Sheirdrim Renewable Energy Development

Additional Information

**RE: SHEIRDRIM RENEWABLE ENERGY DEVELOPMENT, ARCHAEOLOGY AND CULTURAL HERITAGE
RESPONSE TO HISTORIC ENVIRONMENT SCOTLAND LETTER OF THE 30TH OF MARCH 2020**

**RE: SHEIRDRIM RENEWABLE ENERGY DEVELOPMENT, ARCHAEOLOGY AND CULTURAL HERITAGE
FURTHER CLARIFICATION TO HISTORIC ENVIRONMENT SCOTLAND**

Ferry route between Kennacraig, Kintrye to Port Askaig, Islay, Point B

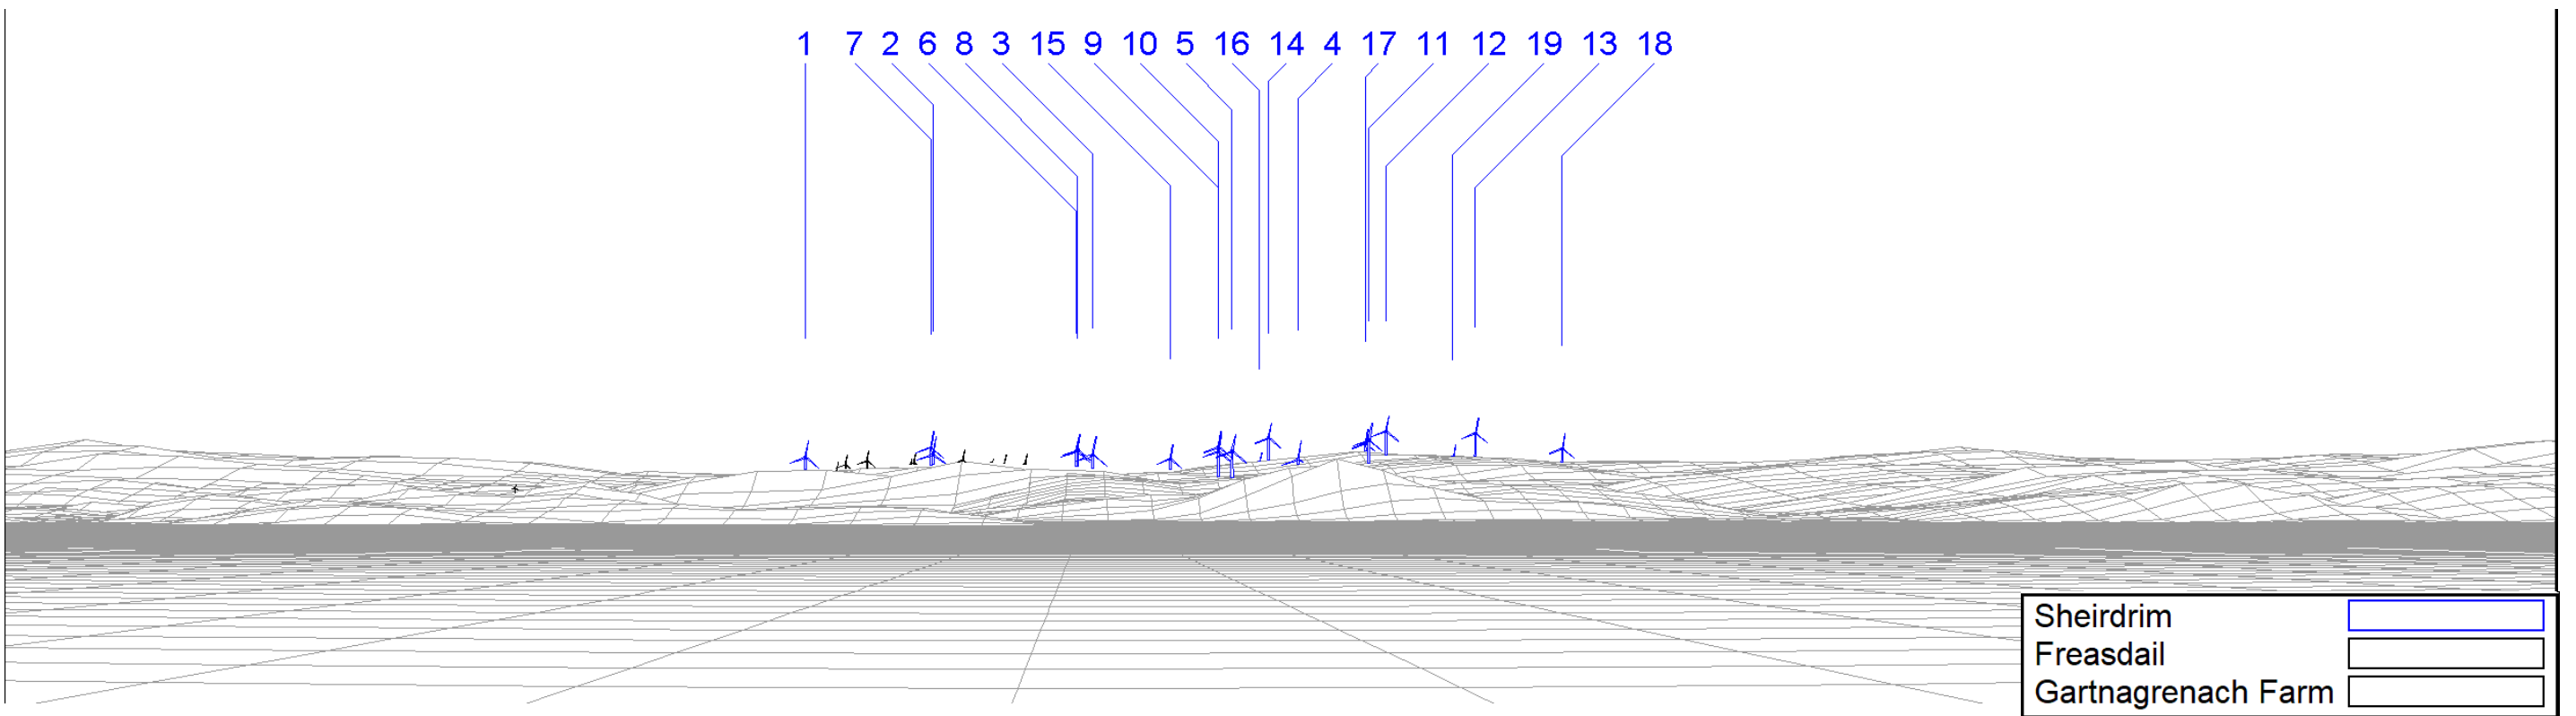
'As demonstrated in the supplied visualisations (ferry route wireframes Point B and Point C), the proposed turbines would be clearly visible on the skyline directly behind Dun Skeig in most inward views

from the sea. The turbines would surround and appear above the Dun in these views, thereby competing for dominance with and diminishing the visual prominence of Dun Skeig.

The Freasdail turbines already appear in many of these views. However, these newly proposed turbines would be taller and located further west than Freasdail. The resulting impact would be significantly greater, being more prominent, more concentrated directly above and behind the Dun, and across a wider area of the surrounding skyline. When closer in to the coast (for instance to the east of the northern tip of Gigha), these turbines would also remain visible whereas the Freasdail turbines currently drop out of view.

As viewed from Point B there is a clear separation of the turbines from the fort by the intervening higher ground, which largely screens Turbines 3, 6, and 8. Although the proposed turbines would appear in the backdrop and to the right of the view of the fort, they would not significantly detract from an appreciation of the fort's relationship with the sea or its location upon a prominent coastal hill. Closer to the monument the proposed turbines become less visible before being screened from view entirely (see Figure 11.1 of the EIA Report).

In the wireline drawing from Point C the proposed turbines appear above the skyline and behind the monument, particularly turbines 4, 5, 9 to 12, 14, 16 and 17, and in closer proximity than to those of Freasdale Wind Farm which are not discernible in the photograph. At 8km from Dun Skeig, the hill itself is not as prominent in comparison to closer locations as represented by Point B, being one part of a wider view with landforms behind the hill forming the skyline. The relationship between the monument and the sea at this distance are also less easily appreciated. At 12km from the nearest proposed turbines, the turbines themselves are unlikely to be as visible against the skyline as suggested in the wireline drawings. They would form a minor component of the landscape where visible, and not overly detract from the potential appreciation of the monument at this distance.

Figure 3
View from Ferry at Point B
Photomontage

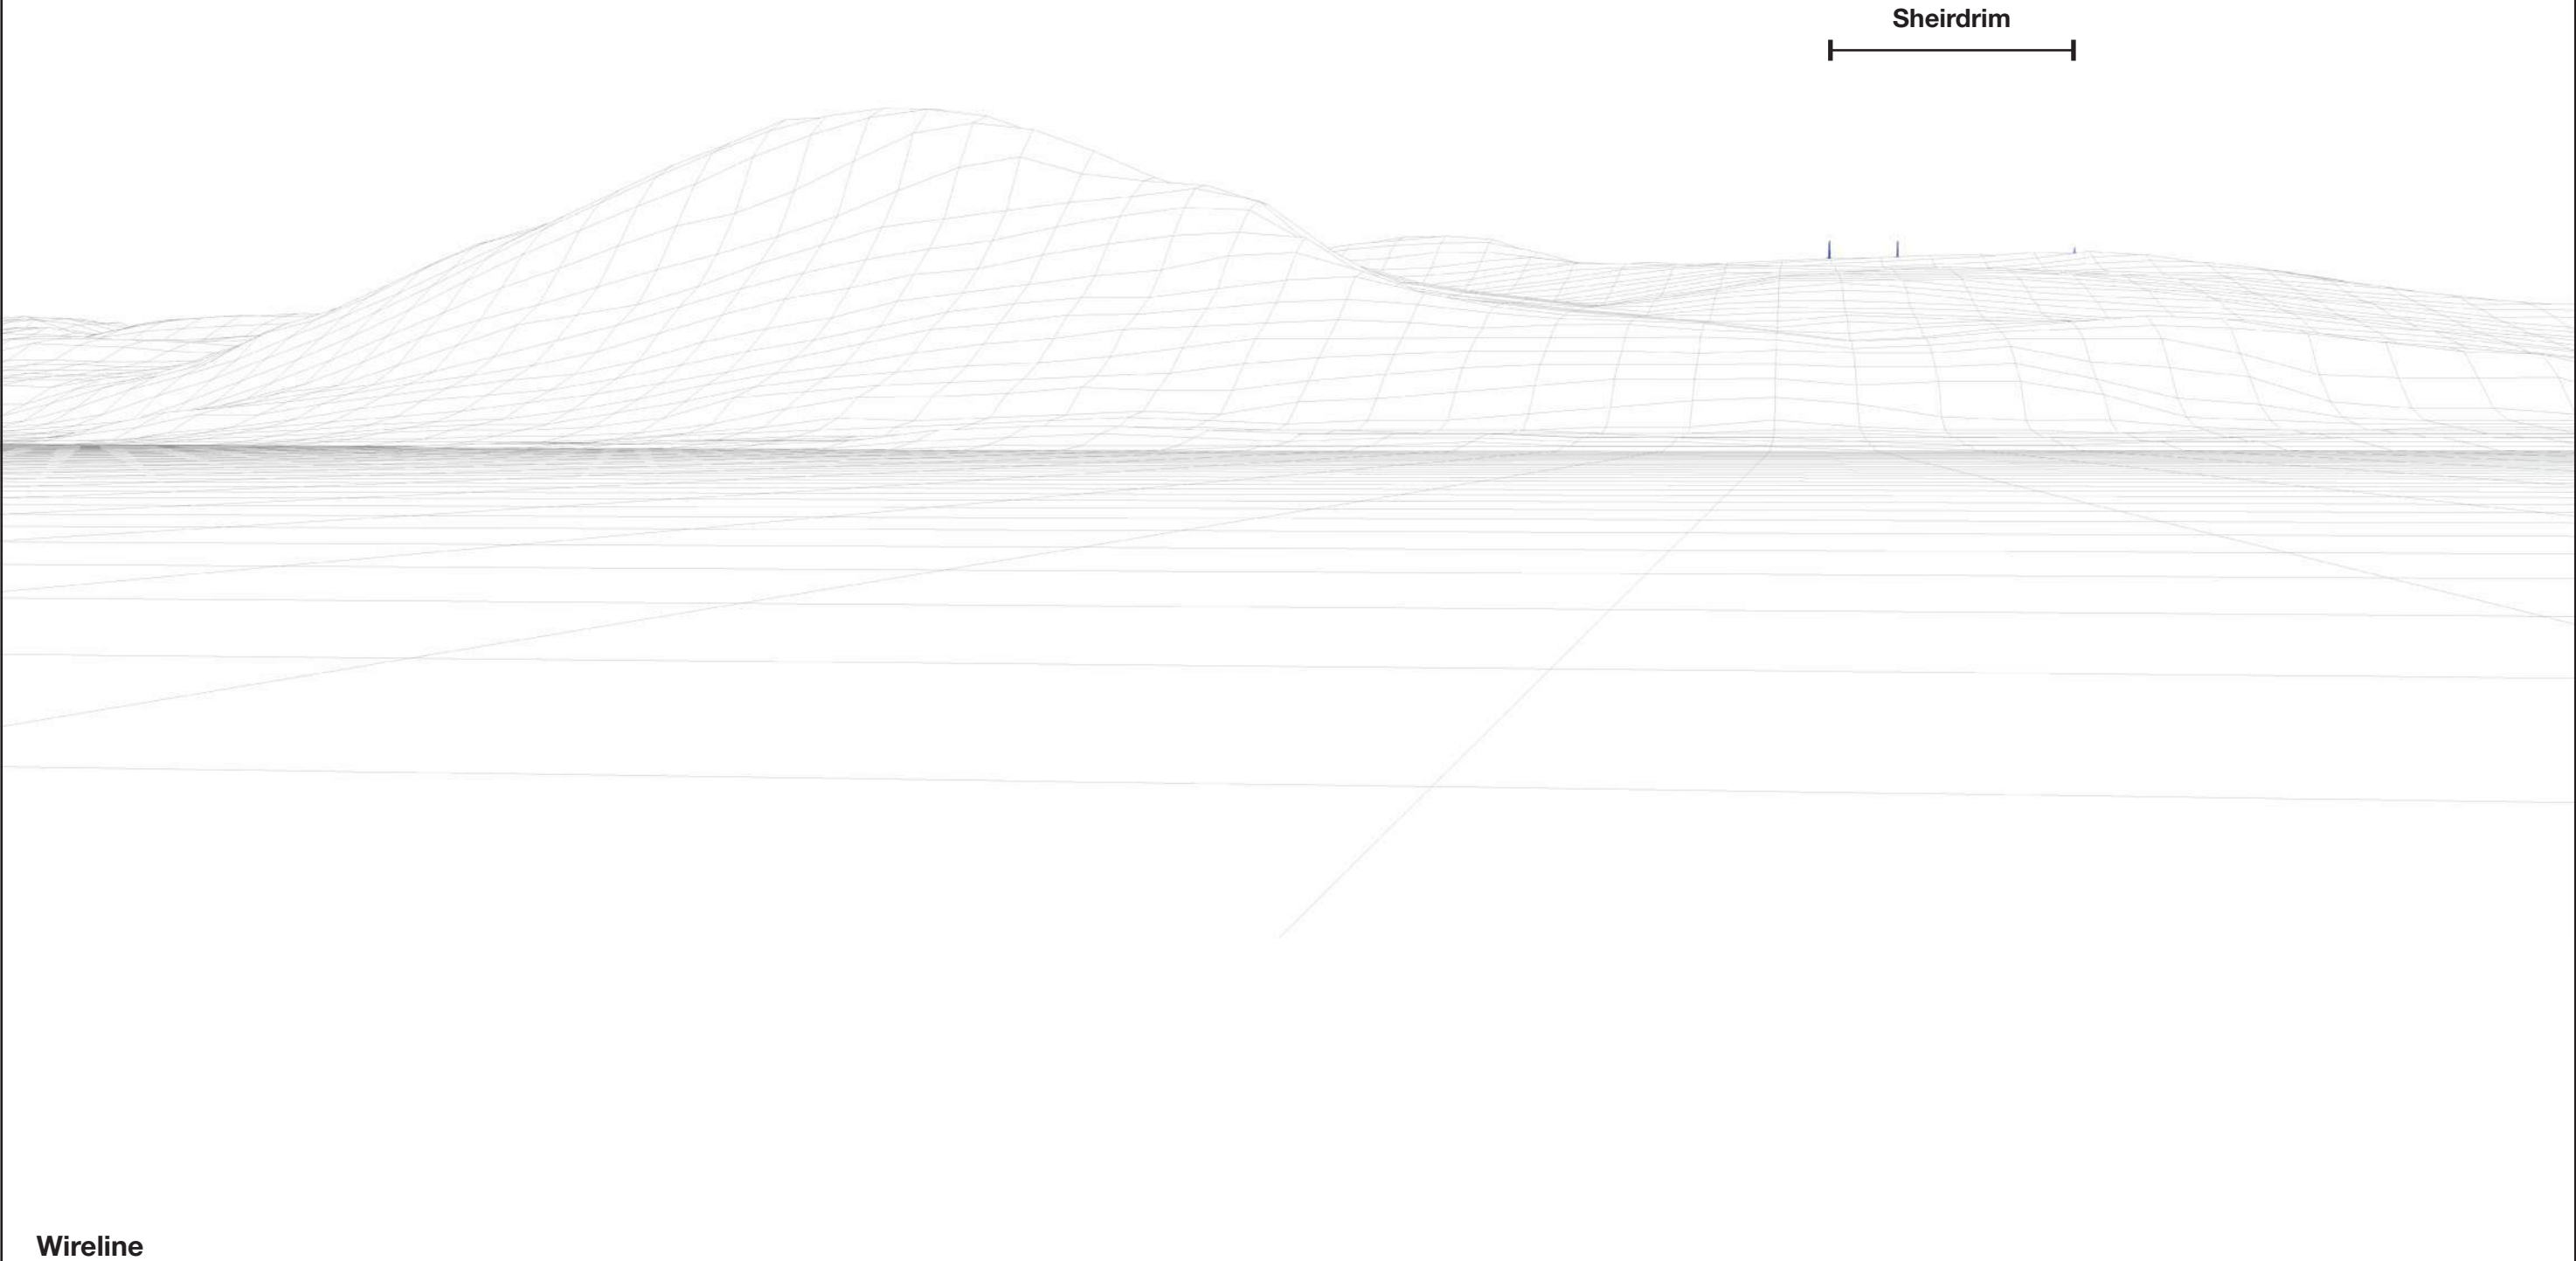
'As noted in our letter of 30 March 2020, the existing Freasdail turbines are already visible in many of these views, including those from the Kennacraig ferry. We therefore do not agree that the proposed Sheirdrim turbines would appear as recessive features.'

Further to this, we consider that inward views of Dun Skeig from the waterways around West Loch Tarbert make an important contribution to the setting of the monument. Dun Skeig dominates the coastline and its prominent position demonstrates the control held by the monument over the wider waterways. Even today, Dun Skeig is used as a reference point when navigating at sea. It should be noted that Dun Skeig is a distinctive coastal feature in the panoramic photographs and wireframe views provided. These include the photographs taken at Point B and Point C on the ferry route between Kennacraig and Port Askaig. These inward views contribute to our understanding, appreciation and experience of the monument.'

The proposed turbines do not intervene between the monument and its maritime setting, in that they are within the central upland part of Kintyre behind the monument as viewed from the sea outwith West Loch Tarbert. The photomontages from Points B and B2 (Figures 3 & 5) provide a better indication of the scale of the proposed turbines, as viewed from near the entrance to West Loch Tarbert, than previously supplied wireline drawings.

At positions closer to the monument, B1, B and B2, there is a perceived separation between the proposed turbines in the background and Dun Skeig in the middle ground. The scale of the turbines, in comparison to that of Dun Skeig, means when viewing the position of the dun and fort from these locations it is the hill and the monument's position upon it that form the dominant landscape feature. Although visible within the central upland part Kintyre, the turbines do not significantly detract from the appreciation of the monument's maritime setting or its position in relation to the entrance to West Loch Tarbert. The wireline in Figure 4 (Point B) and photomontage of Figure 5 (Point B2) allow the landscape to the north east, and left of the monument in the view, to be presented with the visualisations centred on the hill. In Figure 4 any proposed turbines to the left of the Dun Skeig are screened from view by the topography. In Figure 5, six turbines of the proposed Development to the left of the monument appear as turning blades only. The wireline drawing provided in Figure 2 from Point B1 demonstrates how quickly the turbines go out of view as you get closer to the monument, with just two blade tips visible. As viewed from these locations the proposed turbines would erode to a minor degree the heritage significance of the Dun Skeig scheduled monument and the ability to experience it, although a full appreciation and understanding of its strategic role and heritage significance would be unaltered.
